Subject: RESPONSES TO RFI #001

Project: RENOVATE EXTERIOR – BUILDING 1109

Job #: ANG# FAKZ162109
SSL# 18078

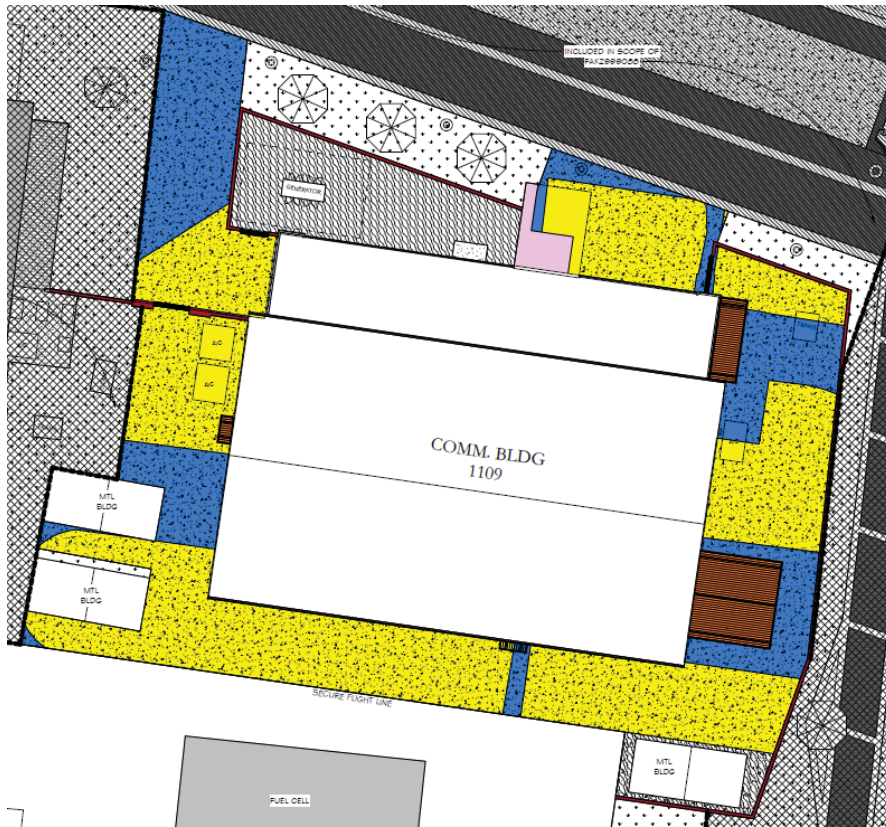
10) Question: Can a plan be provided that clearly shows the areas to be paved in CLIN 0001 vs the areas to be paved in CLIN 0002?

Response: See attached. CLIN0001 is intended to include all pavement systems to be installed where existing paved areas exist on the current size. The approximate location of paved areas included in CLIN0001 are represented in blue on the attached drawing. CLIN0002 is intended to include all pavement systems to be installed in current non-paved, grass areas that exist on the current site. The approximate location of paved areas included in CLIN0002 are represented in yellow on the attached drawing.
